Appropriation (Loose Fill Asbestos Insulation Eradication) Bill 2014/15

The report prepared by/for Roads ACT in relation to the extension of Nudurr Drive – can the Committee be provided with a copy of the report.

Re: 816701 – Response to Auditor Comments Regarding Review of the Robson Phase 1 Environmental Site Assessment Report, Nudurr Drive Extension, Gungahlin, ACT

To	Stuart McElroy	Robson Environmental	stuartmcelroy@robsonenviro.com.au
cc	Gilbert Ortiz	Brown Consulting	Gilbert.Ortiz@brownconsulting.com.au
From	Mike Nash		Date 13 November 2012
Subject	Statutory Site Audit ACT 004 Contamination Assessment Nudurr Drive Extension, Gungahlin, ACT		Project No. 72812

Figure 8: CSM Cross-Section

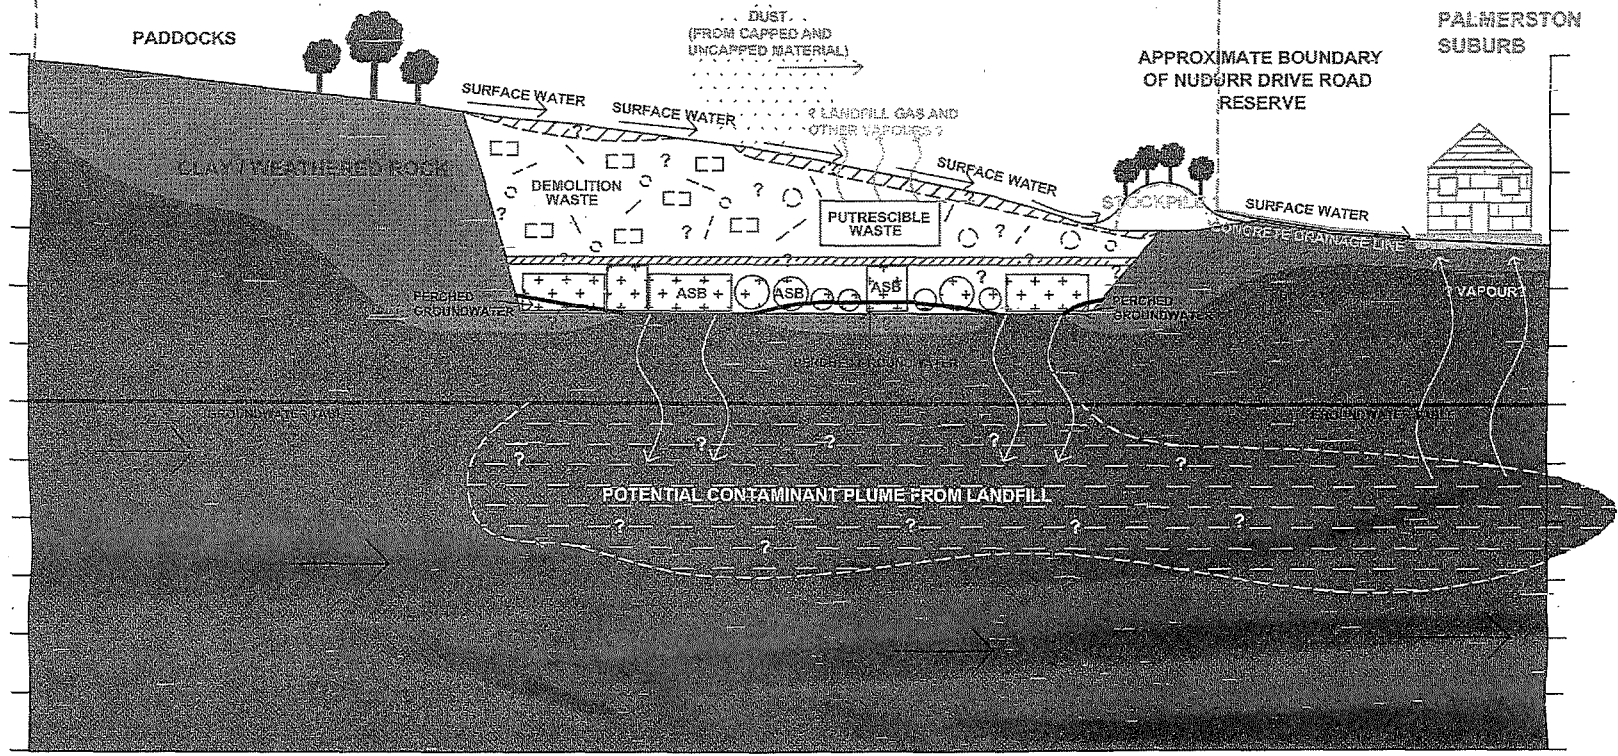
Auditor Comment: *'A CSM – would be useful and could take the form an annotated cross section showing potential contaminant sources, pathways and receptors.'*

A CSM – would be useful and could take the form of an annotated cross section showing potential contaminant sources, pathways and receptors.

Robson Response: An indicative cross section of the conceptual site model for the system is provided in the attached Figure 8. Note that Figures 1 to 7 are in the Phase 1 ESA report.
